# MITIGATION PLAN

## LAUREL SPRINGS SITE

Re: NCIRT Review and USACE Approval of the NCDMS Laurel Springs Mitigation Site / Avery Co./ SAW-2019-00835/ NCDMS Project # 100122

## Response to IRT Comments

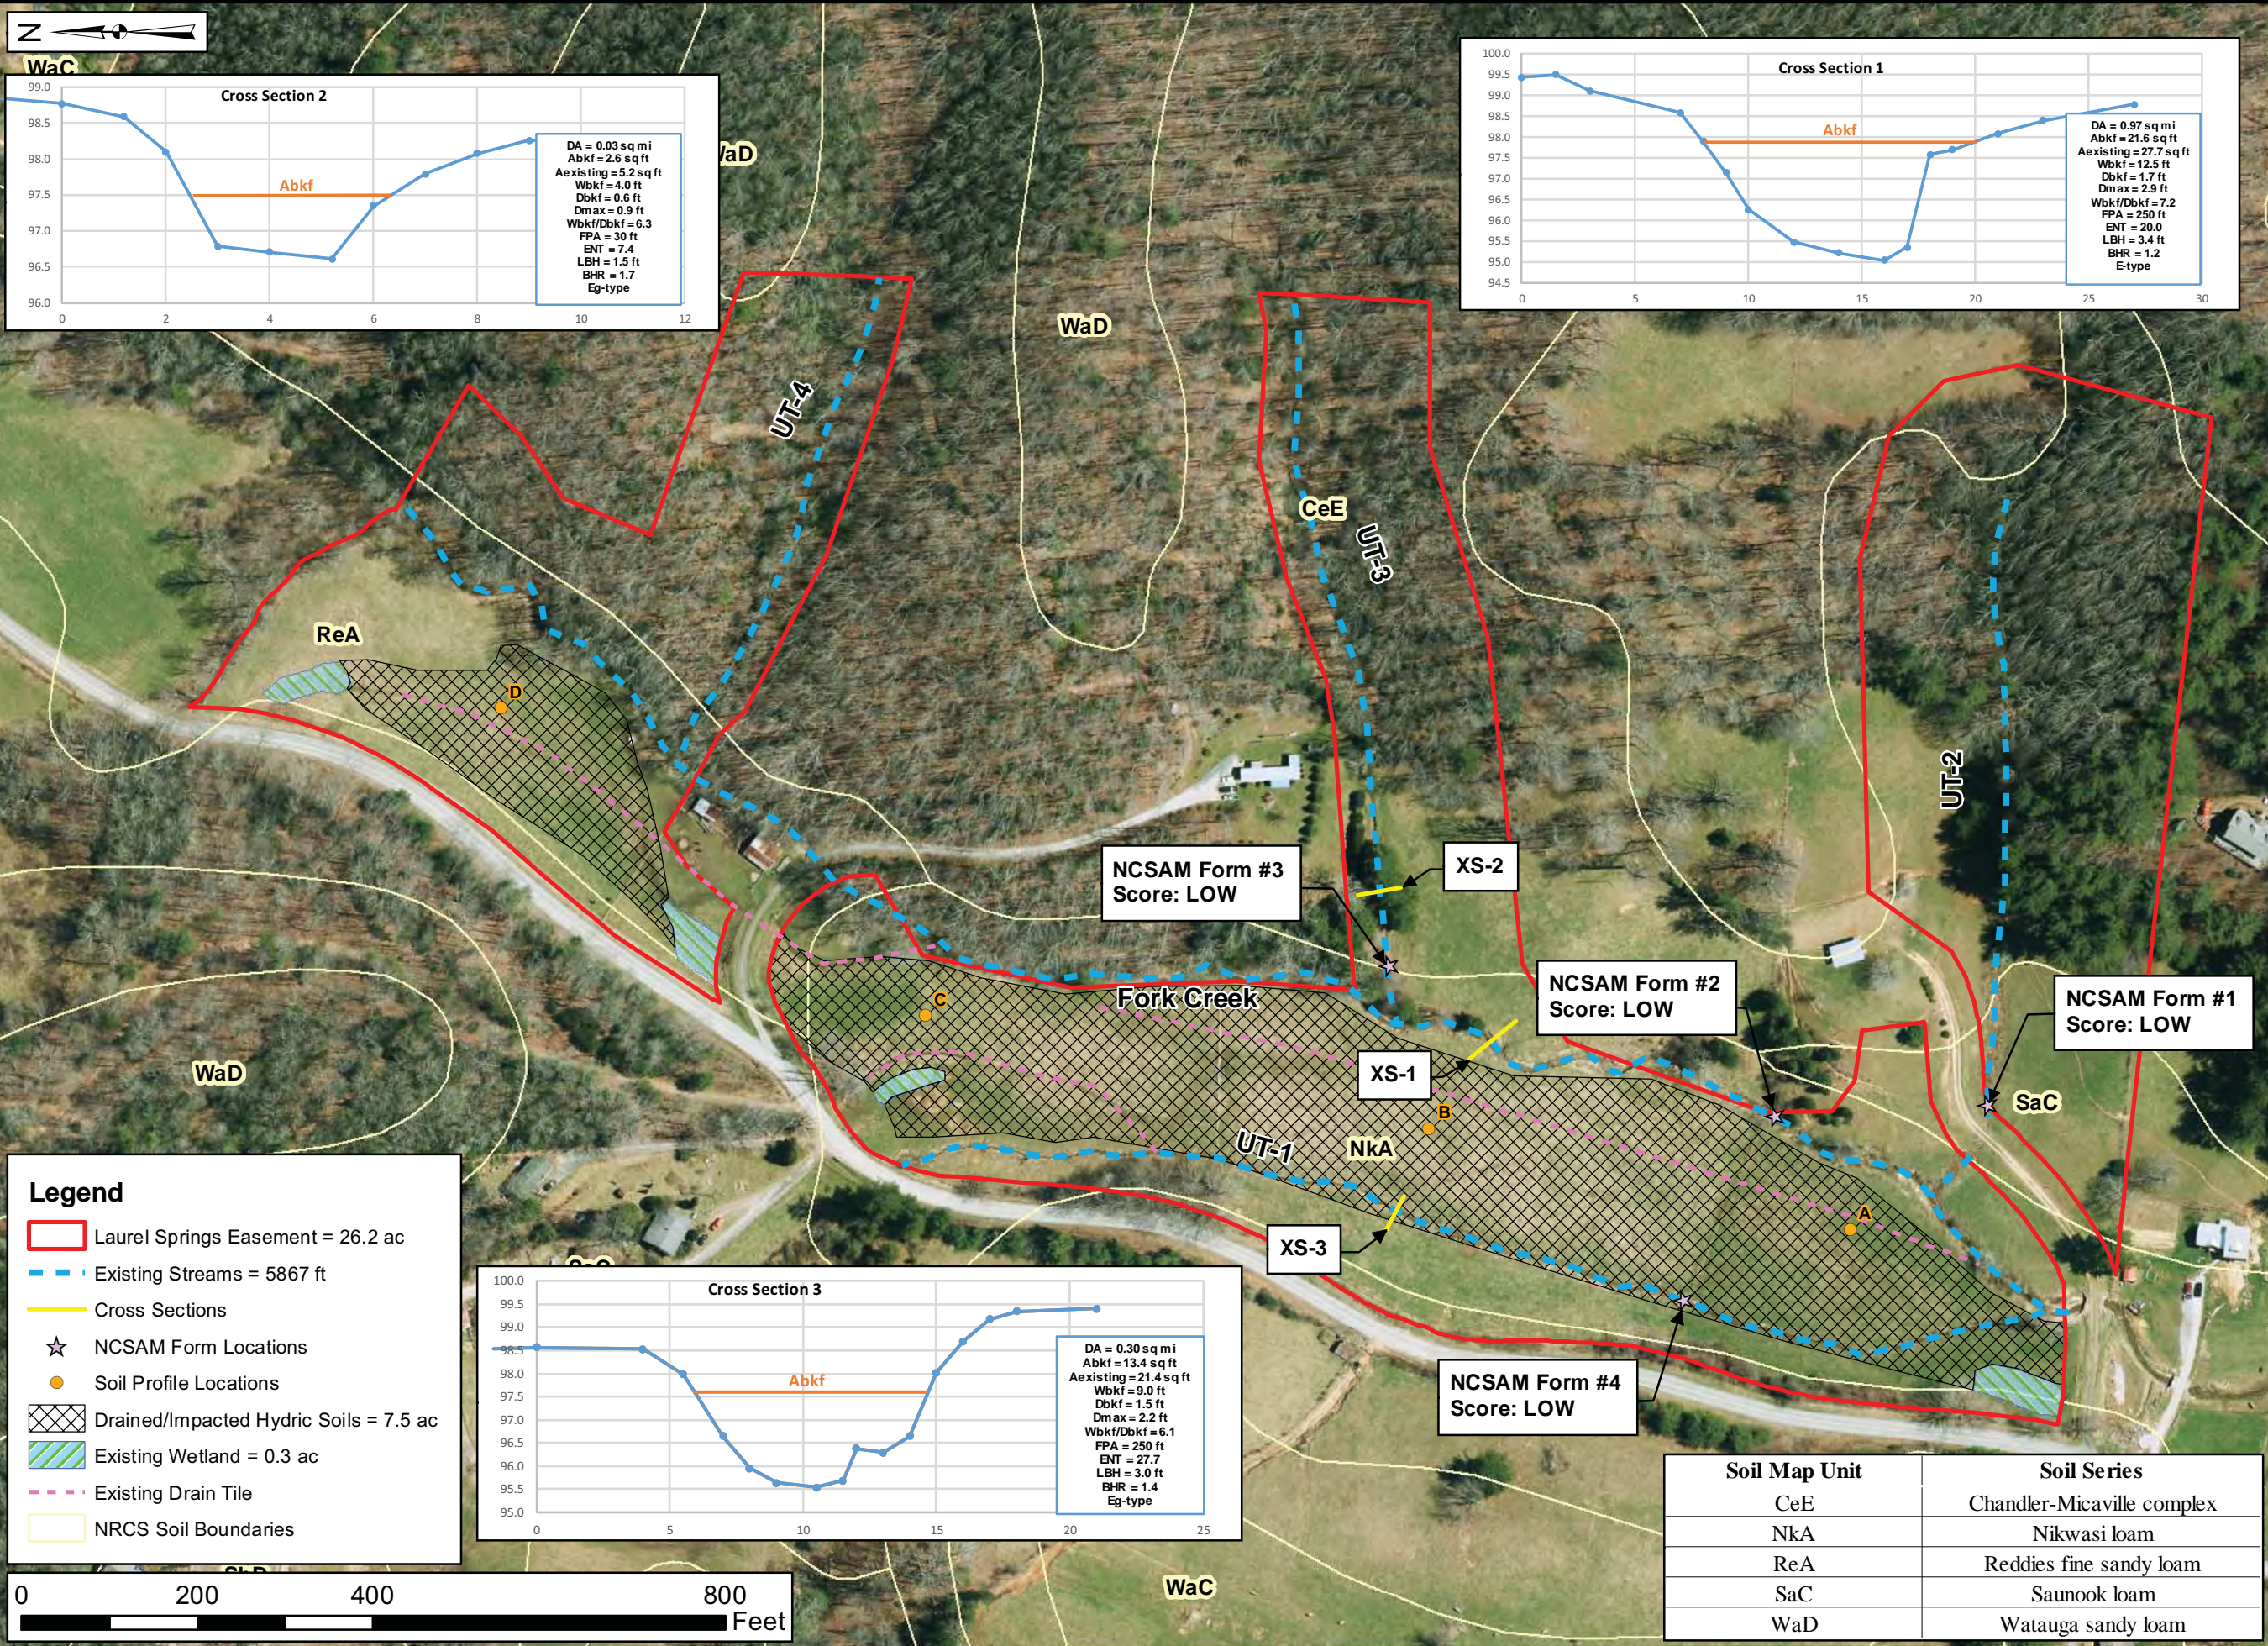
22. Figure 4 – Please shown existing utility lines. Also, can a property boundaries layer please be added to this figure or another figure.  
[Utility lines and property boundaries have been included on Figure 4.](#)

**PLAN AND PROFILE**  
FORK CREEK  
STA. 05+00 THRU STA. 11+00  
**C5.01**

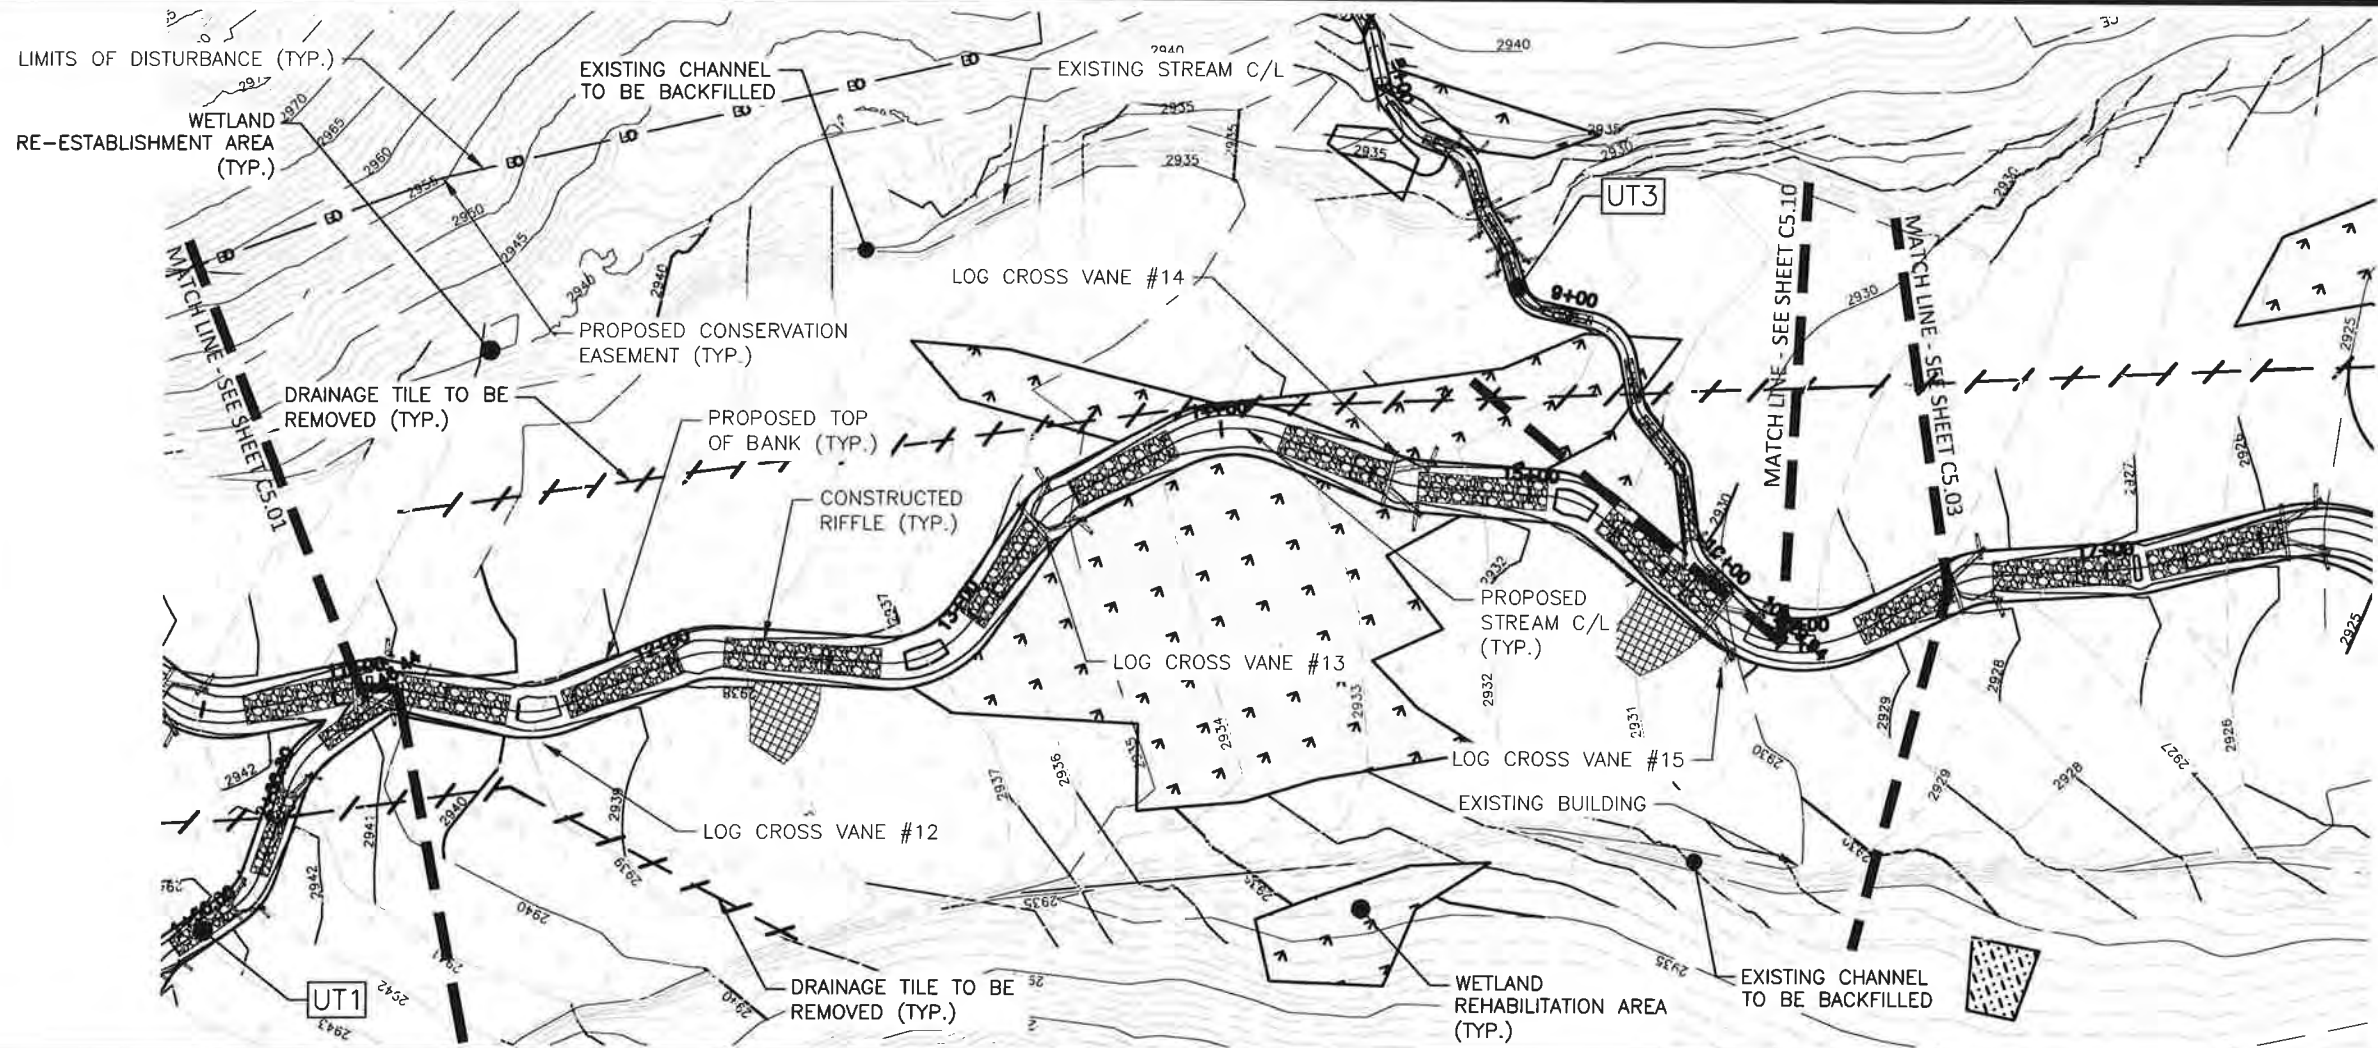
31. Sheet C8.09 – Please clarify whether the proposed aluminum box culvert will be a bottomless span, as called out on Sheet C5.01.  
The Fork Creek crossing will use a full invert aluminum box culvert that will be embedded a minimum of 1' as shown on C8.08.
